### ENVIRONMENTAL IMPACT REPORT

### RITTER RANCH SPECIFIC PLAN (AND ASSOCIATED ANNEXATION AREAS)

**MEMORANDUM TO REVIEWERS  
OF THE FINAL  
ENVIRONMENTAL IMPACT REPORT**

Exhibit 2

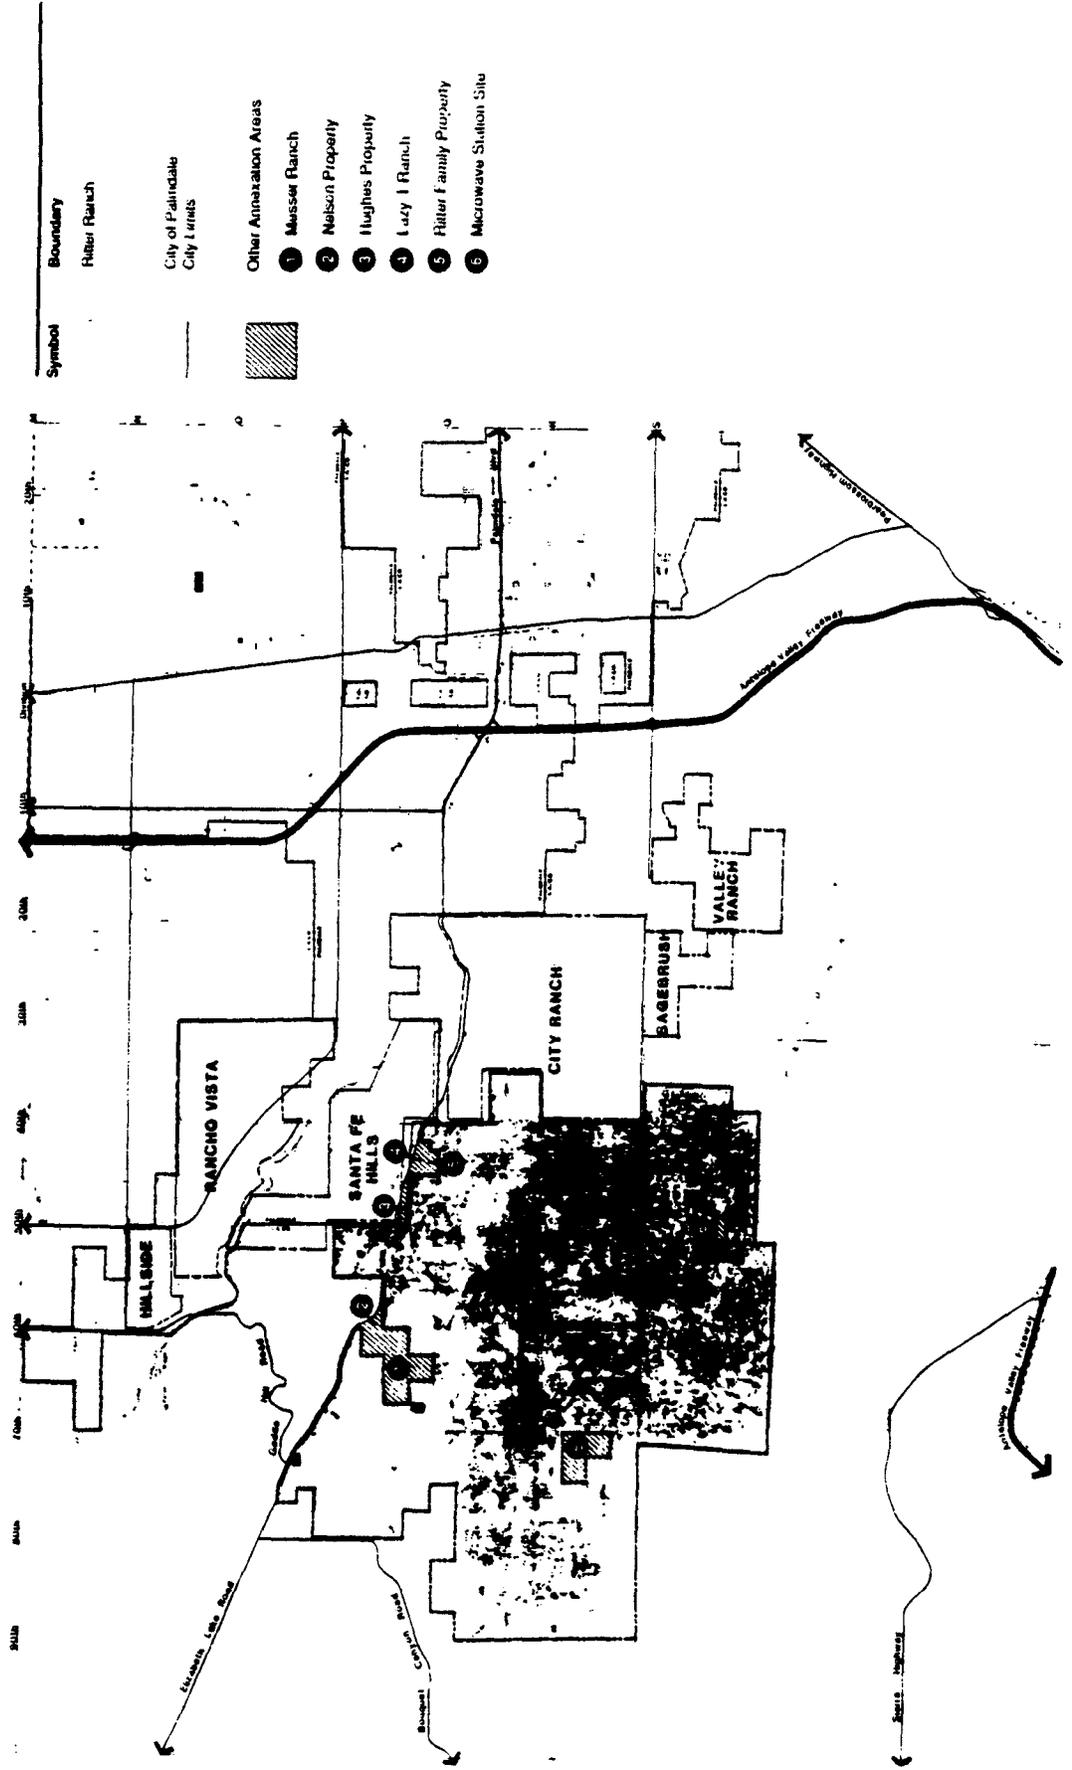
Exhibit 2 Vicinity Map - The map does not show the established community of Leona Valley, which is a very common omission throughout the document. It gives the reader the impression that there is no established community and, therefore, appears to be a direct attempt to minimize the impact of the project on Leona Valley. This misconception needs to be corrected throughout the document as it may be prejudicial to City agencies.

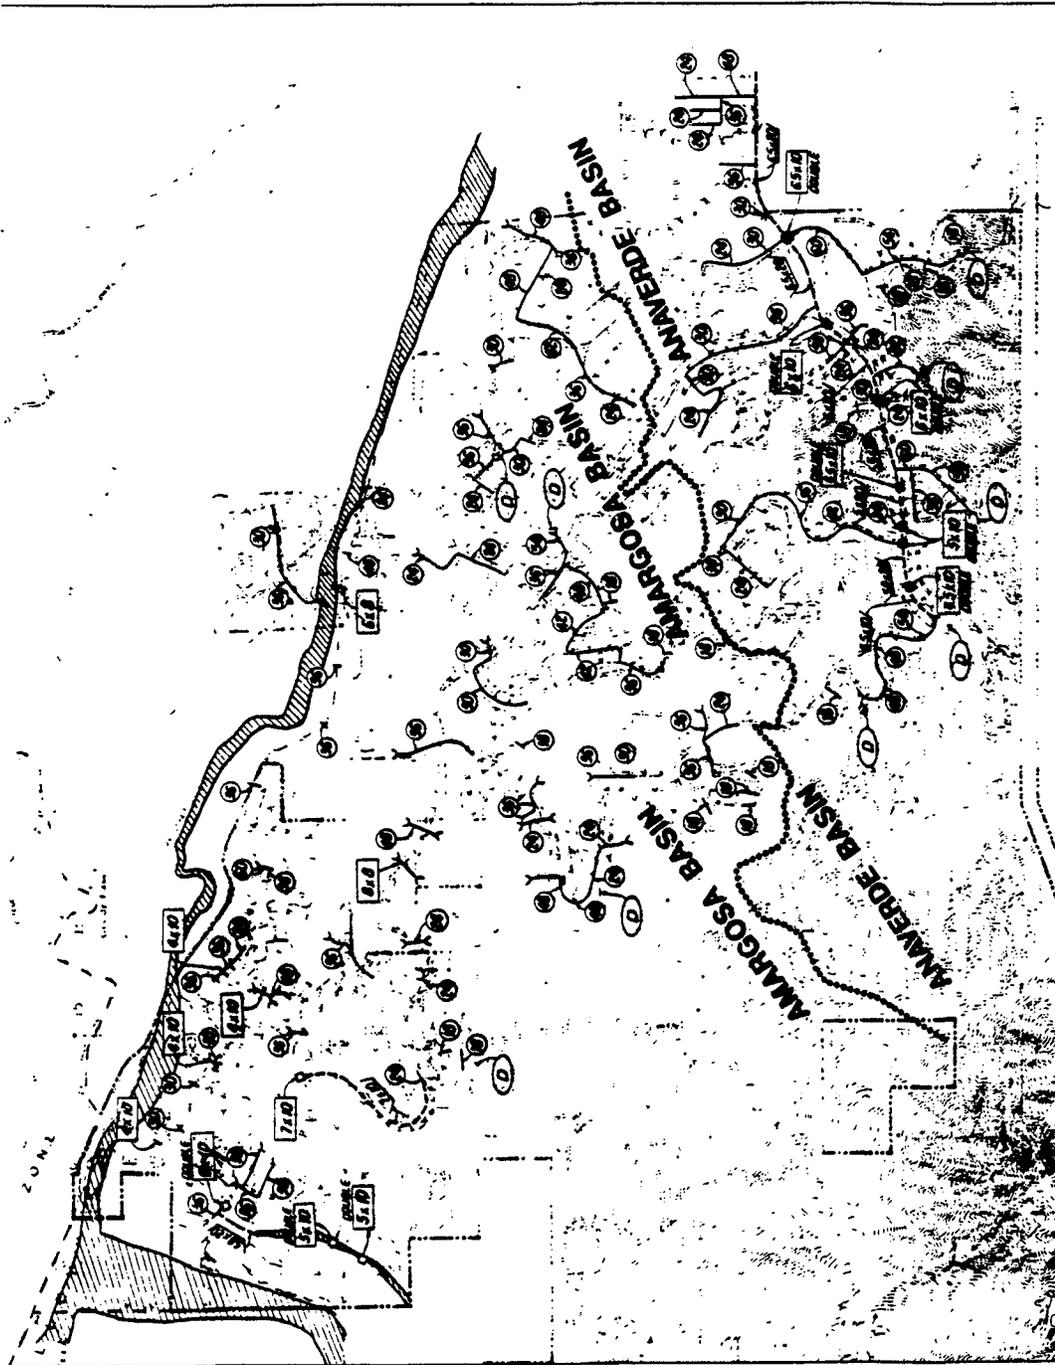
(Page 121) Exhibit 12 does not show the Anaverde flood plain area. Is there a reason for this omission?

- 20tt. Anaverde Creek is discussed on page 122 of the Draft EIR, with facilities conceptually shown on Exhibit 12. Project runoff will be required to maintain or reduce existing storm flows. The Anaverde Creek floodplain is shown on Exhibit 11.
- 20uu. Comment has been acknowledged, and will be considered by the City during project deliberations (this comment pertains mostly to the Amargosa Creek Improvement Project EIR). However, use of the City Master Plan of Drainage is considered appropriate for the project.
- 20vv. This is an Amargosa Creek Improvement Project Assessment District 90-1 issue.
